TRANSPORT ASSESSMENT

PROPOSED WAREHOUSE DEVELOPMENT

PROPOSED LOT 102 FLAGSTONE LOGISTICS ESTATE,
NORTH MACLEAN

(EDQ FURTHER ISSUES LETTER RECEIVED 6 FEBRUARY 2024)

FIGURE 4.8 – SWEEP PATH OF B85 VEHICLES (MANOEUVRING)

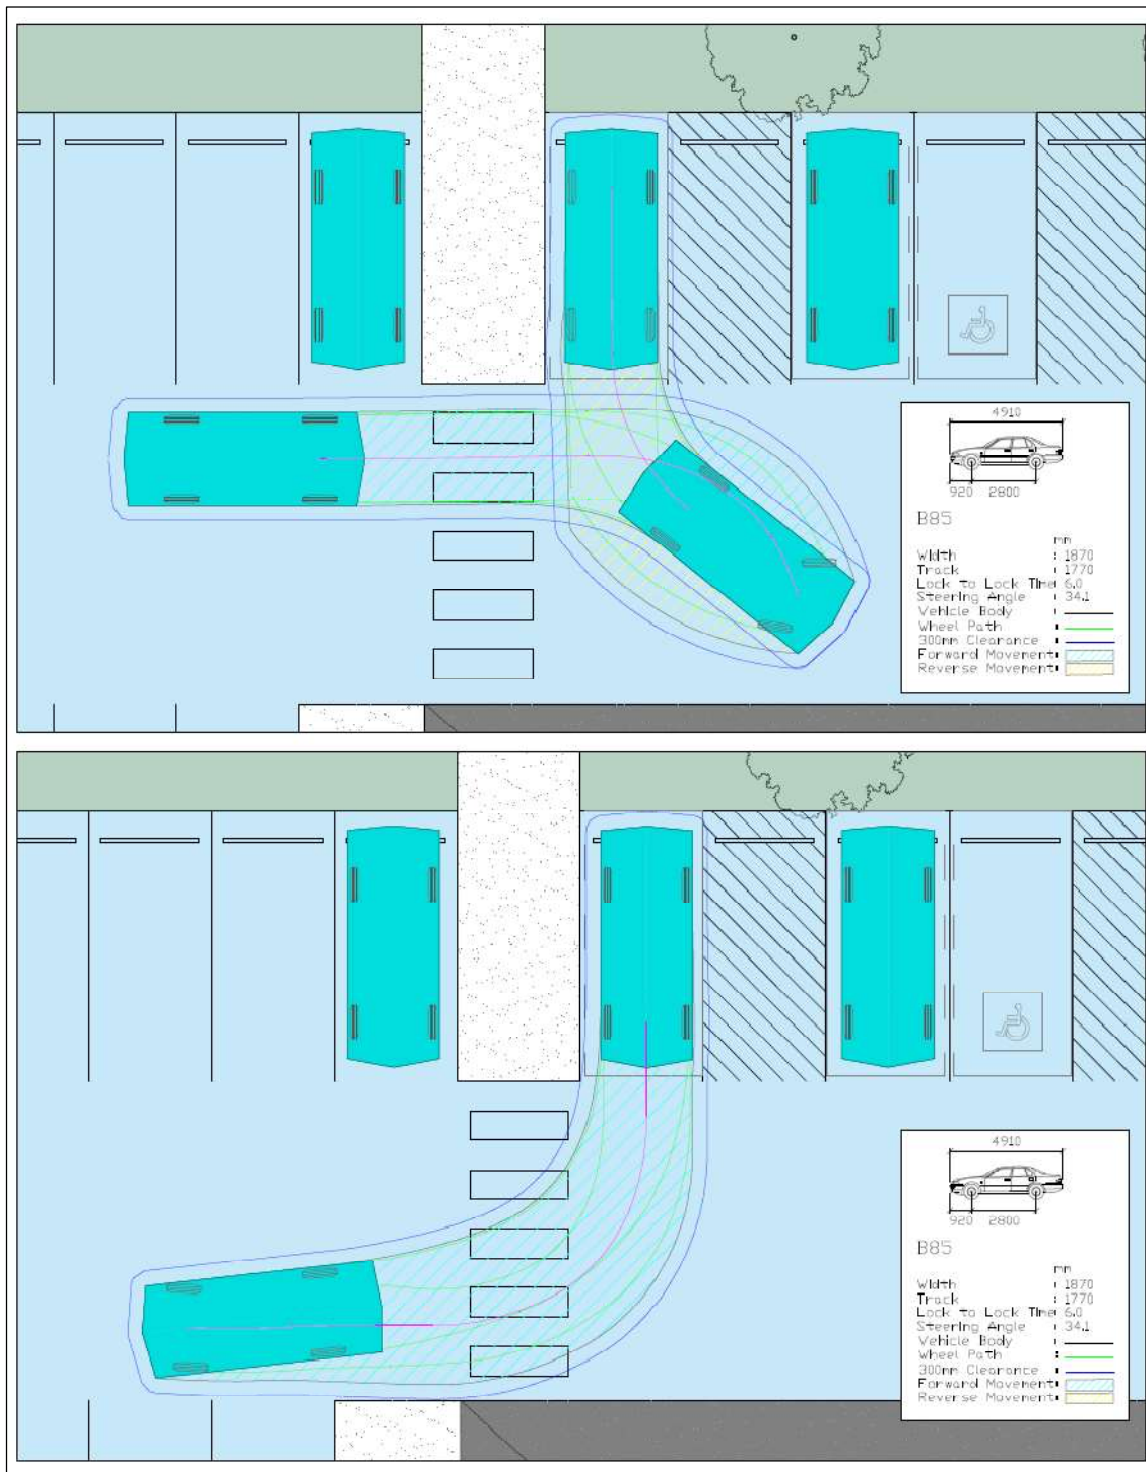
- i. Ensure turning templates (Fig 4.8 & 4.9) align with carpark layout and AS2890 as shown in figure 4.1 of traffic report.
- ii. Provide additional turning paths for Heavy Vehicles entering and exiting designated parking area in accordance with relevant standards.
- iii. Demonstrate key turning paths and parking arrangements for B-Double vehicles are provided within site.
- iv. Confirm that traffic island in figure 6.6 of traffic report is painted and not kerb. If kerb alignment is to be updated to avoid clash with B-Double turning template.
- v. Make minor adjustment to figure 6.2. ensuring that turning template avoid parking bays. Provide dimensions of the parking bays (adjacent the private road) and confirm the vehicle type to be parked in this area.

Please refer to updated swept path diagrams provided in sections 4 and 6.
The traffic island previously shown was intended to be painted only.

FIGURE 4.12 – PROPOSED OVERFLOW CAR PARKING LAYOUT AND DIMENSIONS

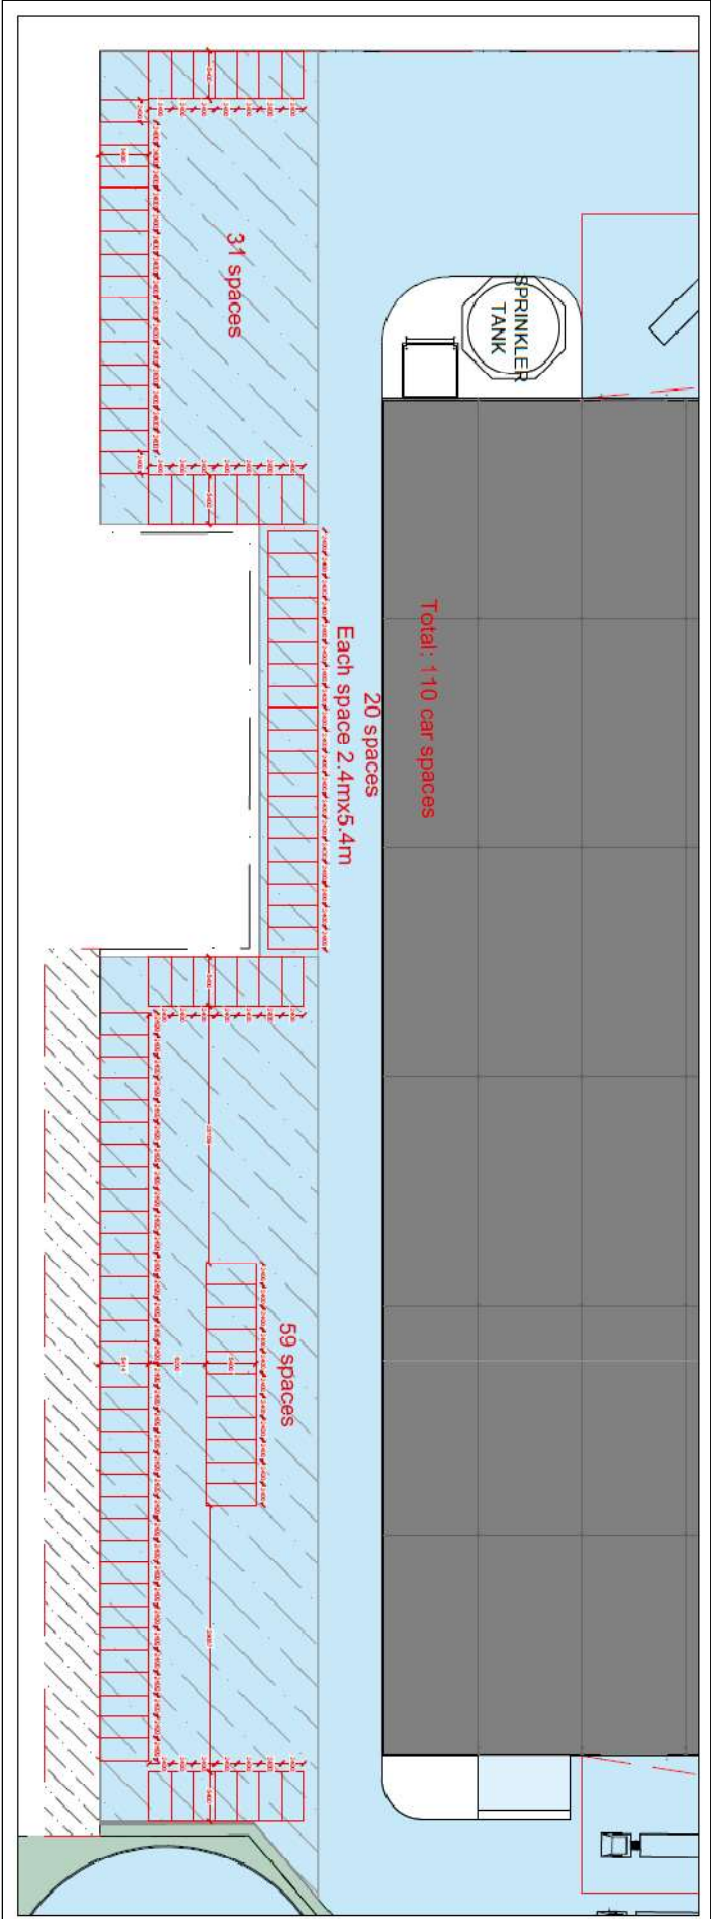
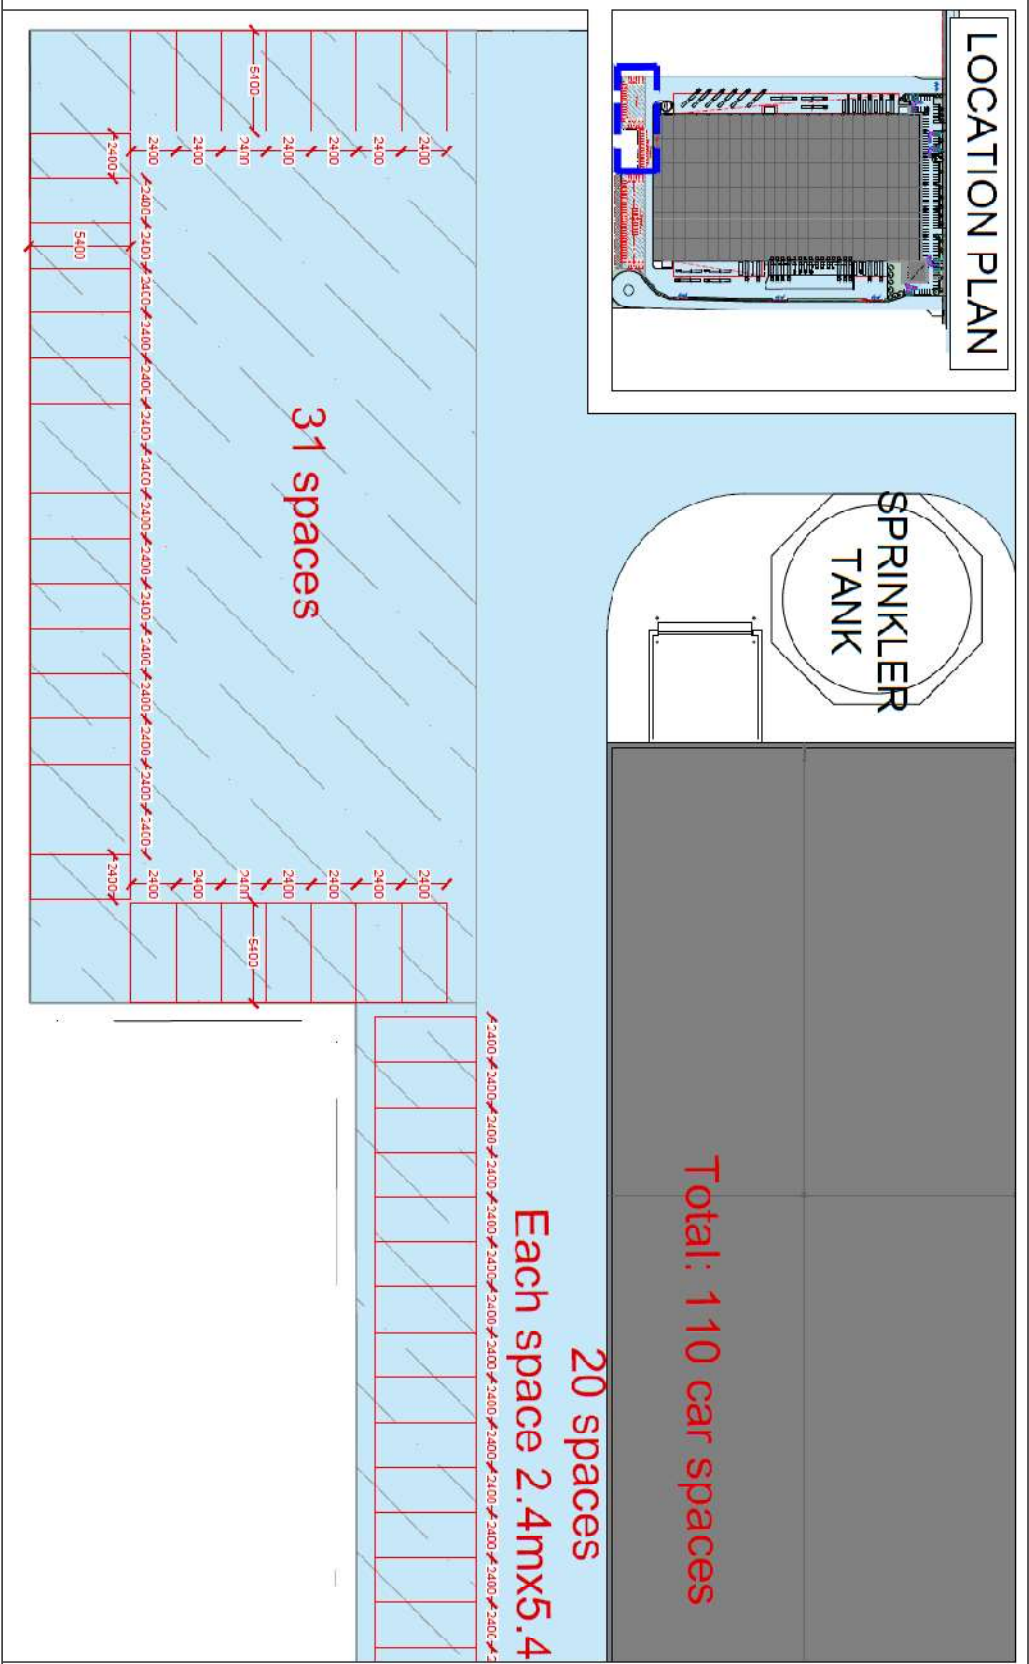
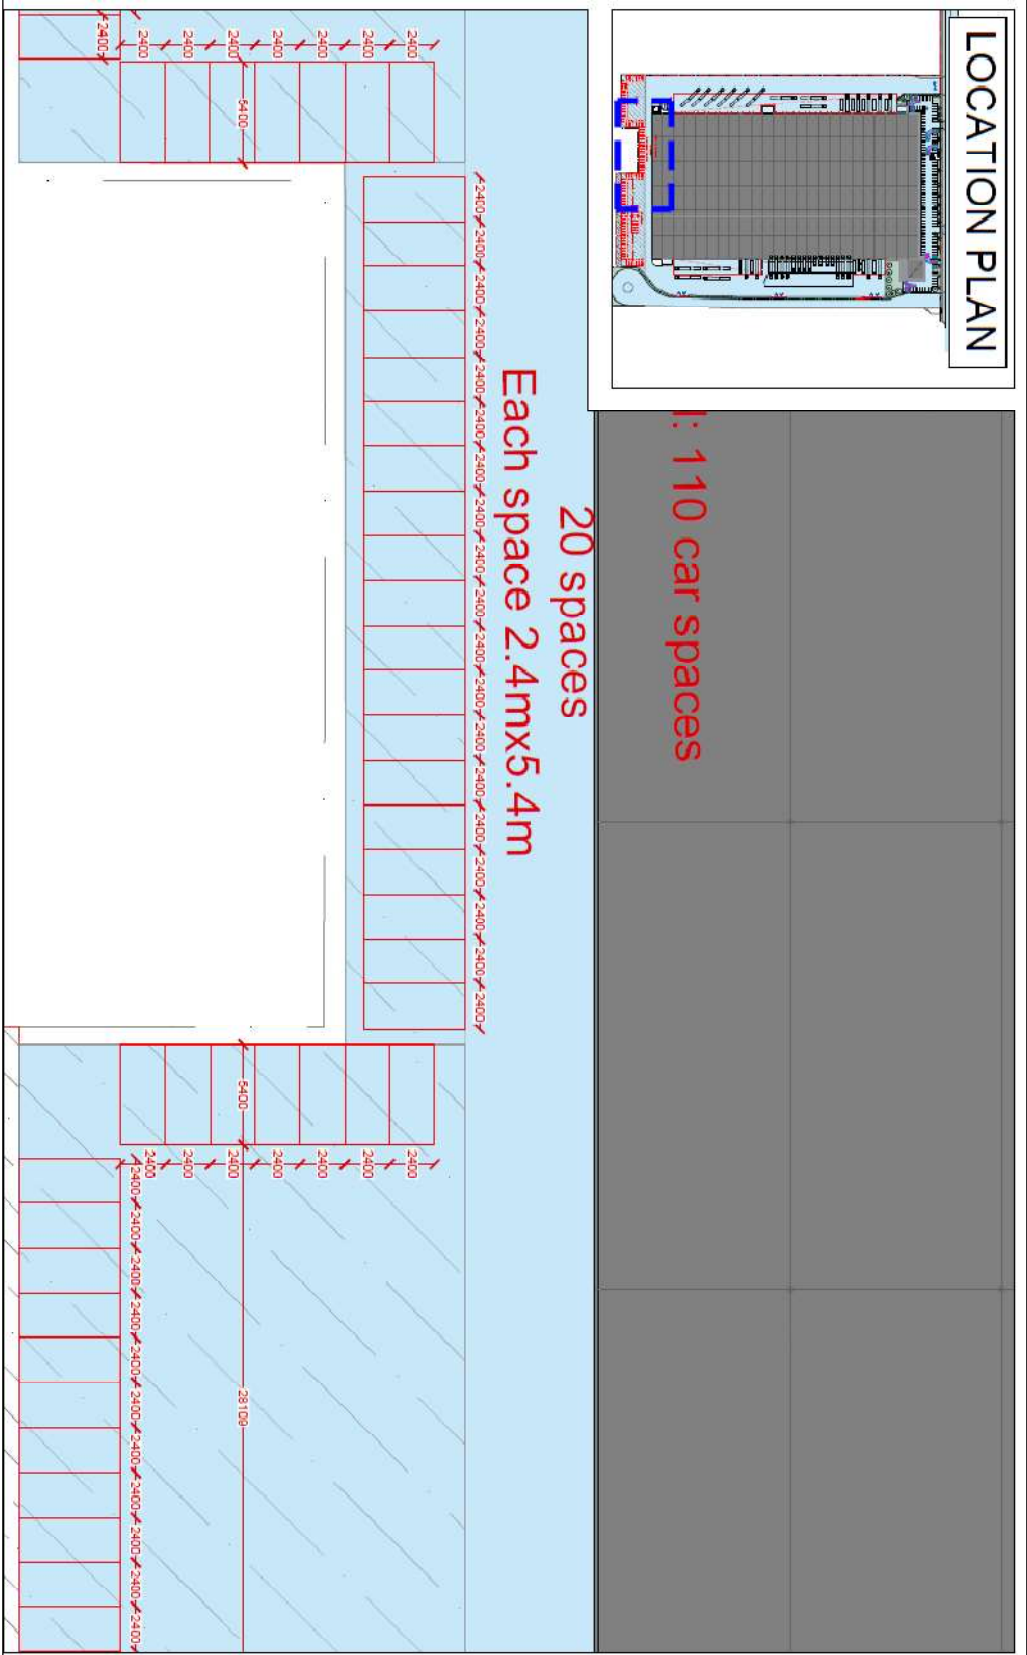
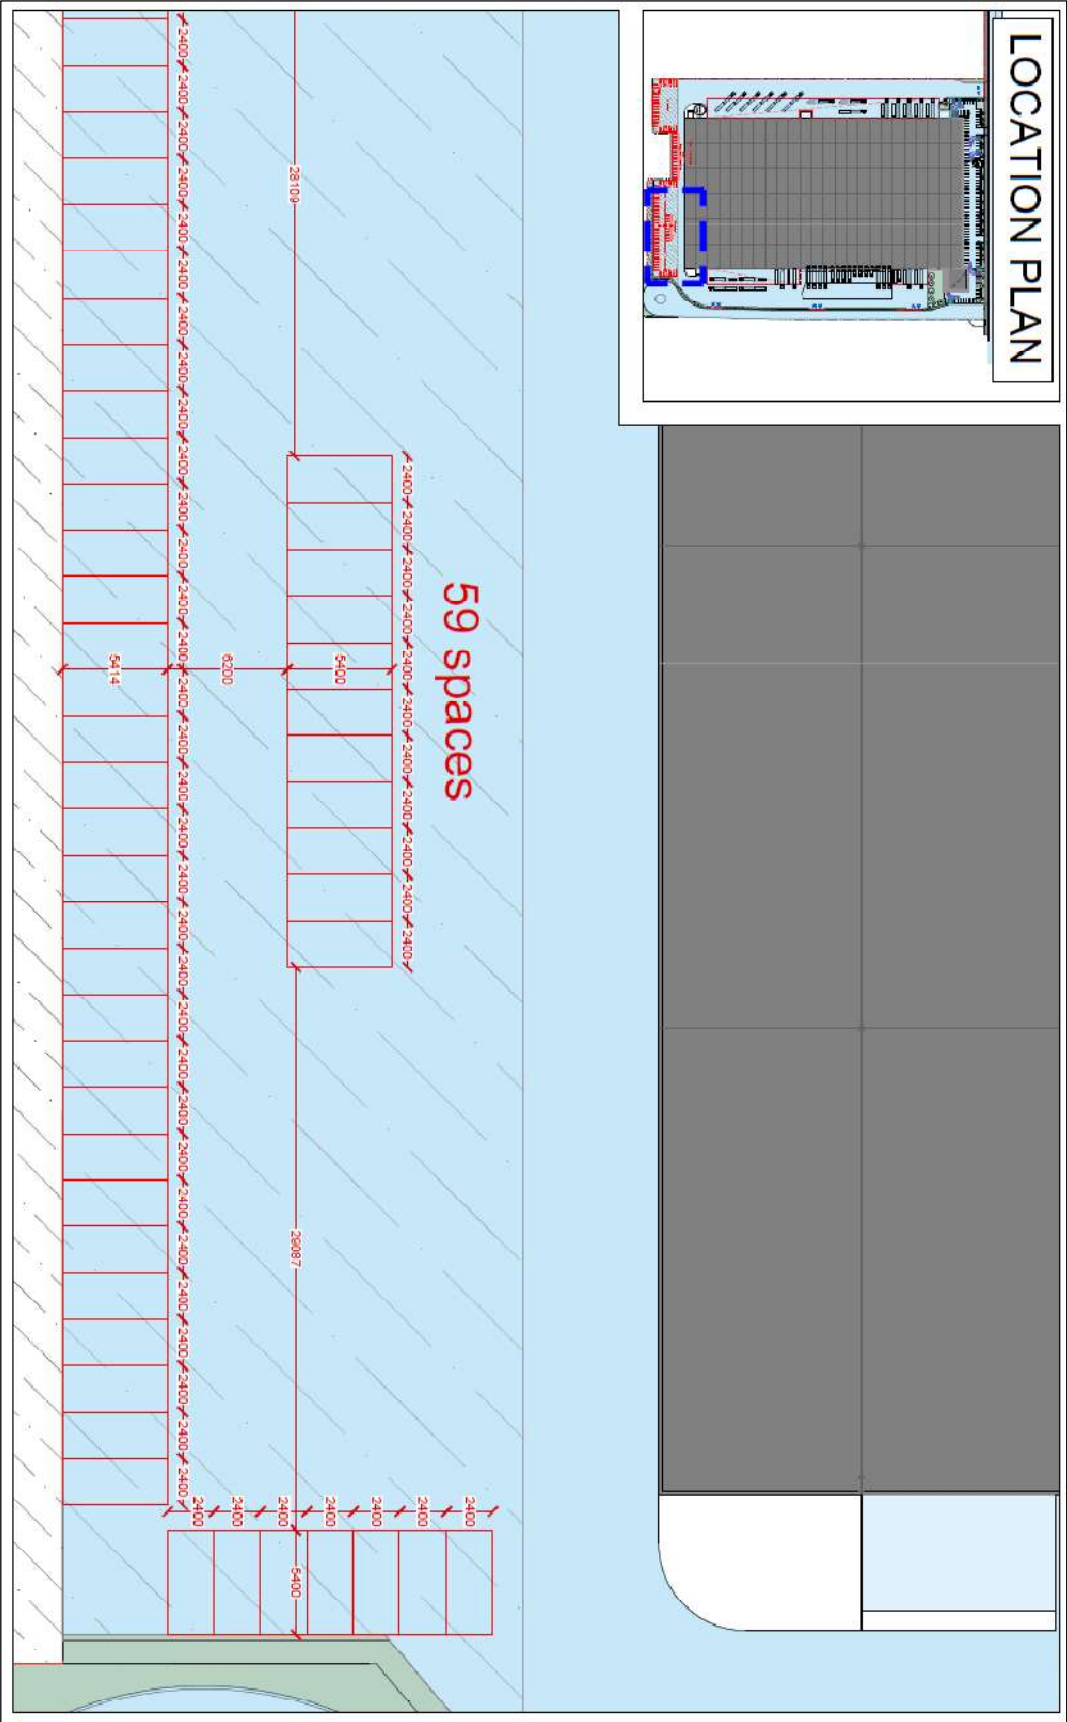
- i. Provide indicative carpark layout for possible additional 110 carpark at rear of site.
- ii. Consideration to be provided to heavy vehicles manoeuvring in this rear of property area. Traffic assessment to demonstrate there will be no conflict between parked cars and heavy vehicles.

An indicative plan of the overflow car parking area over the easement is provided as Figures 4.12-4.15.

FIGURE 7.1 – END OF TRIP FACILITIES FOR CYCLISTS (GROUND FLOOR)

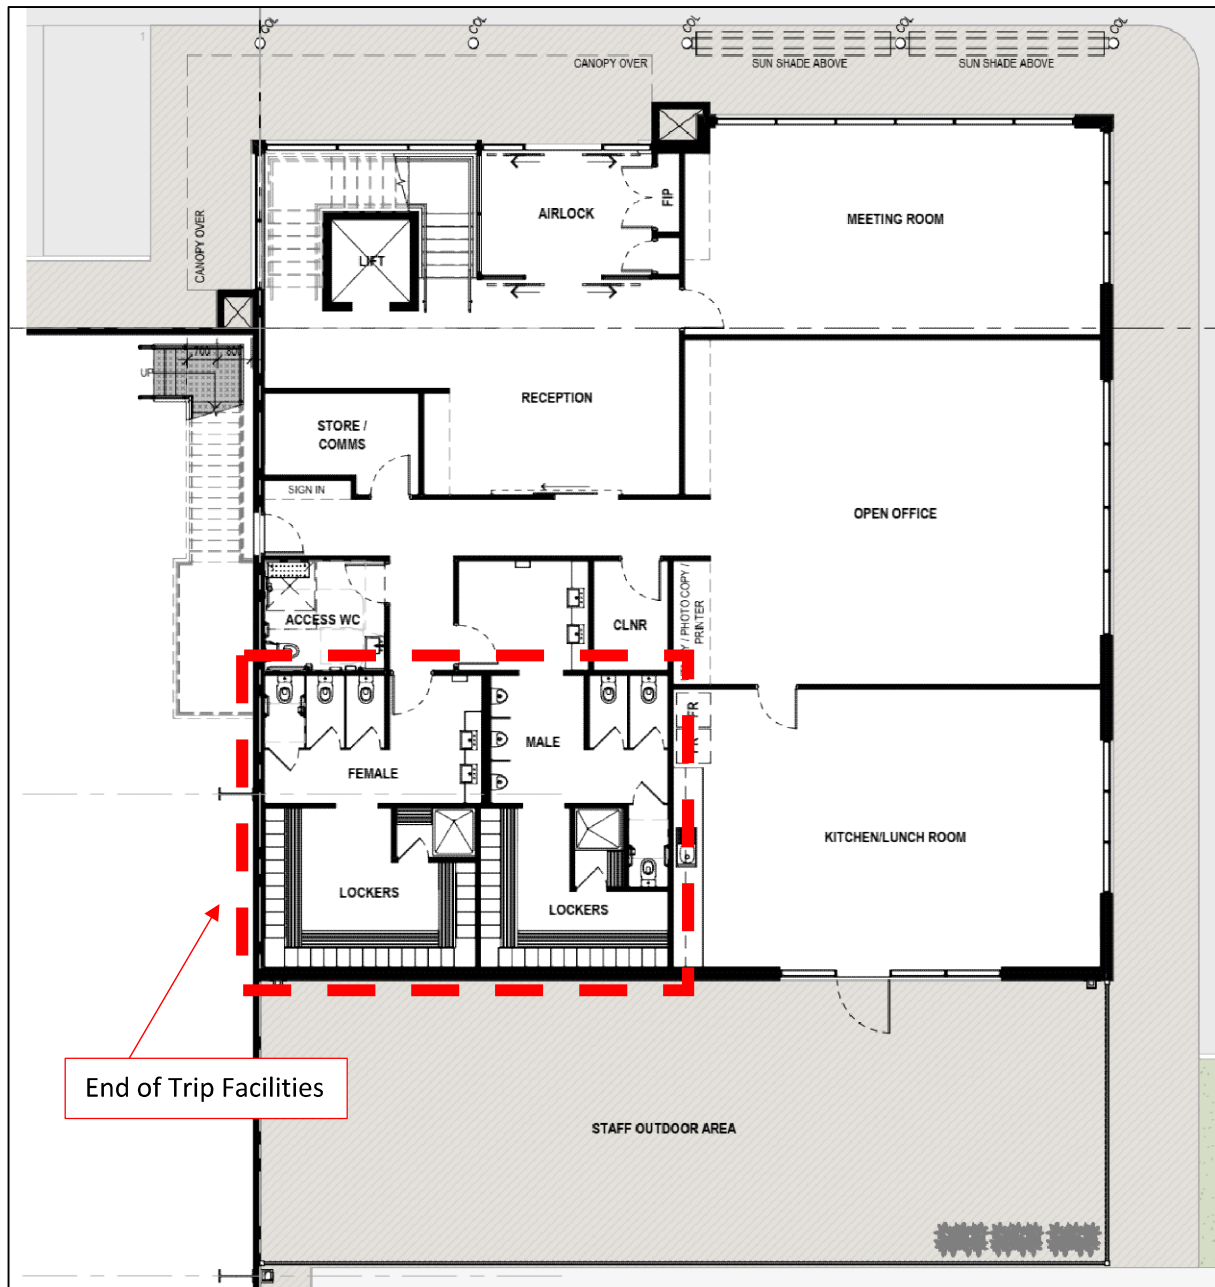
- i. Demonstrate compliance with Queensland Development Code MP4.1 regarding EOT facilities (incl. shower locations) and cycle connectivity through the site. It is recommended that EOT facilities are located near bike parking so that employees do not have to traverse the building to reach EOT facilities from bike parks.
- ii. Provide a safe cycle route through the site that considers heavy vehicle movements.
- iii. A future principal cycle network is proposed along Mt Lindesay Highway. Confirm locations of estate and site access to this future external cycle network.

The proposed bicycle parking and EOT facilities are detailed in section 7. Cyclists will access the building through the car park, away from heavy vehicle movements.
